Introduction of a new regulator connector bracket assy. part no. 951983 for ROTAX_® Engine Type 912 i (Series)

ATA System: 76-10-00 Fuse Box

1.4) Subject

Fig. 1

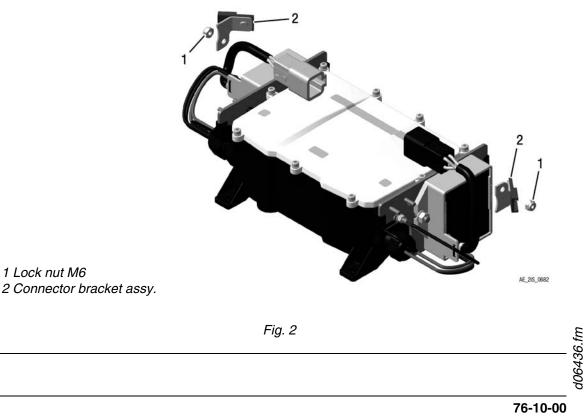
See Fig.1 and Fig. 2.

Step	Procedure		
1	Remove lock nut M6 (1).		
2	Remove washer 6.4 (2).		
3	Install the new regulator connector bracket (Fig. 2, pos. 2) and position correct.		
4	Fasten regulator o the fuse box with lock nut M6 again. Wrench size: A/F 10. Tightening torque: 6 Nm (53 in. lb).		
	NOTE:	Tighten the two lock nuts M6 alternately to ensure a smooth seat of rectifier regulator on the regulator plate.

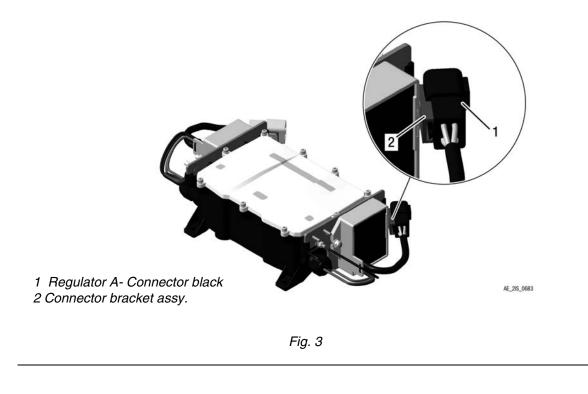
NOTE:	Indicates supplementary information which may be needed to fully comple- te or understand an instruction.		
3.1) li	nstruction - related info	ormation		
	NOTE:	The regulators' female connector housing (Black for regulator A, part no. 864392, Grey for regulator B part no. 864396) already have a molded clip that attaches securely to the new regulator connector bracket assembly part no. 951983.

See Fig. 2 and see also latest Illustrated Parts Catalog of 912 i Series, chapter 76-10-00.
